Bulletin #4 of 2016. April 21, 2016

Change to Product Standardization of Microphones & Earphones

PREVIOUS TERMINAL END

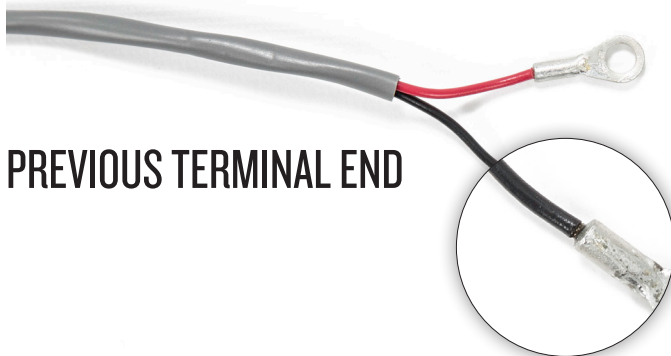
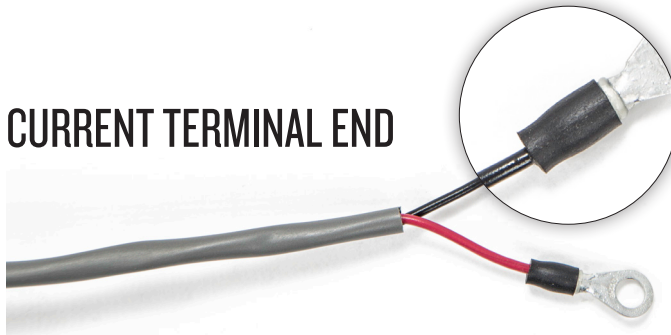
CURRENT TERMINAL END

Standardization is made easy because the two types of mic & earphones are nearly identical, the only difference being that the most current design has shrink tubing on the terminal end of the wire that can help protect against shorting out. Wire lengths have always matched.

515-030 Communications Set is replaced by **515-033**

515-009 Microphone is replaced by **515-029** 9"

515-005 Right Earphone is replaced by **515-018** 9"

515-006 Left Earphone is replaced by **515-019** 15.5"
